Technical Bulletin

HAMMOND ORGAN

NO. MODELS
28 K-100

SUBJECT: REGLUING and/or REPLACEMENT OF NEOPRENE KEY GUIDE

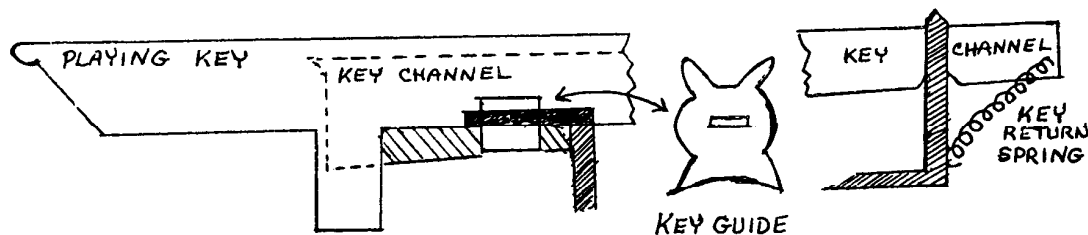
The need for the following correction will be evident by a key, or number of keys, being higher than normal when in their "at rest" position.

Using a long-nosed pliers, unhook the key return spring. Lift the back of the key channel off of the keyboard frame. Slide the key channel assembly forward and off the key guide. Remove the old key guide, if necessary, and scrape off old glue from the key guide frame. Apply "Barge Cement" to the frame and slide on key guide. Keep the small part of the guide up. Apply an additional drop of cement to the front of the guide where it contacts the metal frame. Allow about 30 minutes for the glue to set before installing the key channel and reassembling.
